FOS Universal Oxygen Sensor

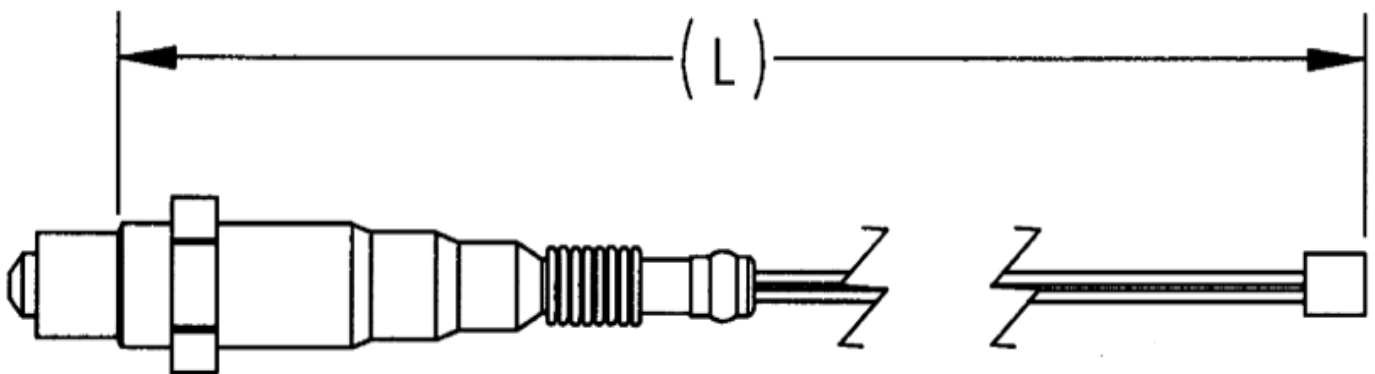
The IMPCO part number FOS universal oxygen sensor overall length has changed. The original length was 210 mm. The new length is 141 mm, shown by dimension "L" below.
